Title: Rehabilitation and development of the Information and Discovery Centre, Forillon National Park		
Solicitation No.: / N° de l'invitation : 5P201-18-0090/A	Amendment No.: / N° de modification de l'invitation : 011	Date: August 13, 2018 Date : 13 août 2018
GETS Reference No.: / N° de référence de SEAG : PW-18-00832432		
Solicitation Closes: / L'invitation prend fin :		
At: 02:00 PM	On: August 16, 2018	Time Zone: Eastern Daylight Time (EDT)
À : 14h00	Le : 16 août 2018	Fuseau horaire : Heure avancée de l'est (HAE)
Address Inquiries to: / Adresser toute demande de renseignements à : Nicole Levesque-Welch		
Telephone No.: / N° de téléphone : 819-420-9868	Fax No.: / N° de télécopieur :	Email Address: / Courriel : nicole.levesque-welch@pc.gc.ca
TO BE COMPLETED BY THE BIDDER (type or print) À ÊTRE COMPLÉTER PAR LE SOUMISSIONNAIRE (taper ou écrire en caractères d'imprimerie)		
Vendor/Firm Name – Nom du fournisseur/de l'entrepreneur

AMENDMENT 011

This amendment is being raised to respond to questions submitted in response to solicitation 5P201-18-0090/A.

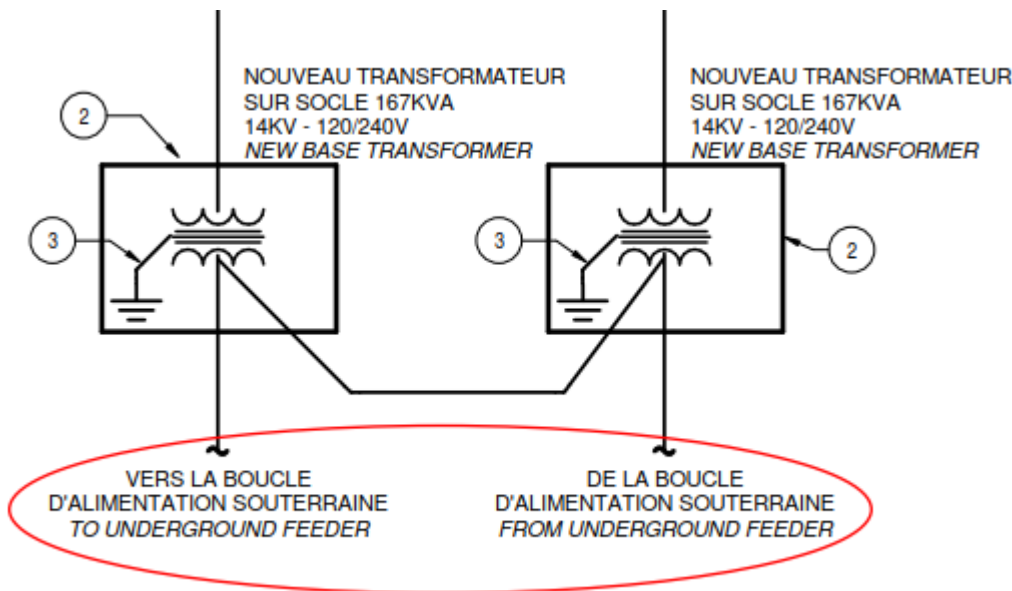
Q51. More details are required regarding the connections of the two base transformers to the underground power loop, see sketch. Clearly indicate in a plan view the layout, type and size of the cables, the type of trench and the method of connection to the network. The information provided to the documents is insufficient. Also, specify whether the underground medium voltage network is a private network or Hydro-Québec.

A51. We don't have more details to provide. The cables size is shown on plan EL103. It is a private network.

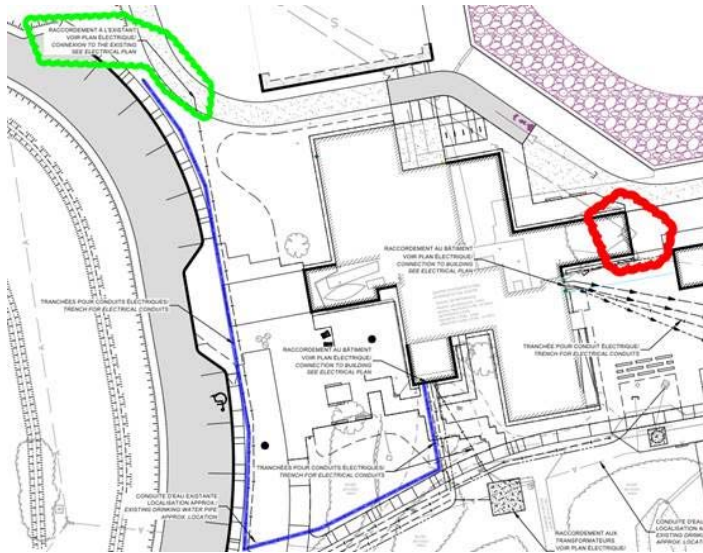
Q54. Can you tell us the usefulness of the electric trench in blue represented on the Civil drawing C17? See sketch :

A54. This trench is not required and is removed from the drawings and specifications.

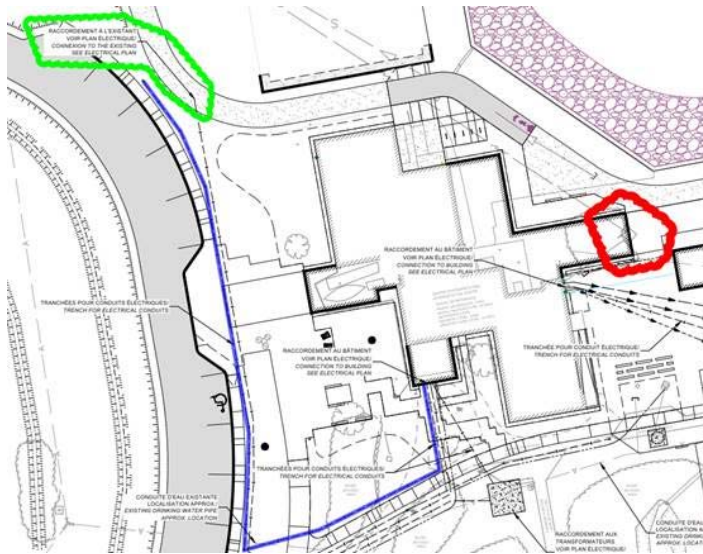
Q55. The existing pedestal transformer shown on the C17 civil engineering plan and circled in red in the following sketch is likely to be removed at the beginning of the work to allow the construction of the foundations. No electrical indication indicates this. Is it the responsibility of the general contractor, the electrician or the PCA to remove it and dispose of it? You will also understand that once this transformer is removed the building will be without power.

A55. The transformer must be dismantled. This will be corrected in addendum.

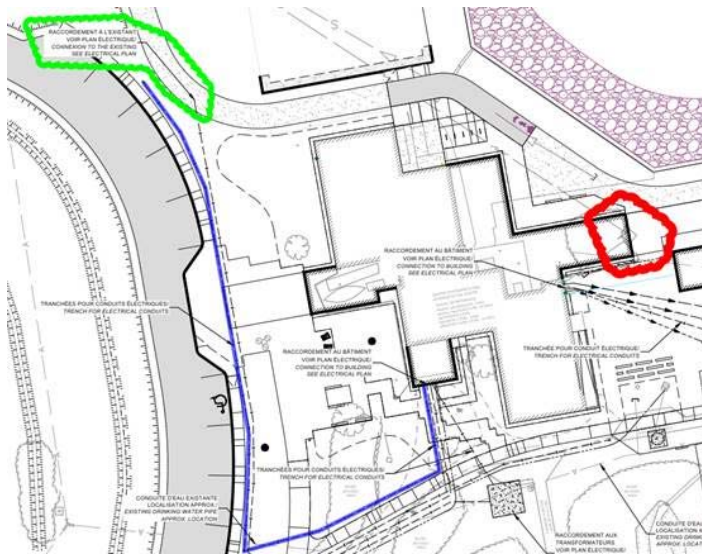
Q56. In connection with a question previously asked about the connection of the two new transformers to the existing medium voltage loop in the email below. You indicated a connection point to the civil engineering plan C17 circled in green on the attached sketch. We need more details on the method of connection to the underground network. No underground power line passing at this location is shown in the plan.

A56. The existing electric cable needs to be located at the construction site and routed to the new transformers.
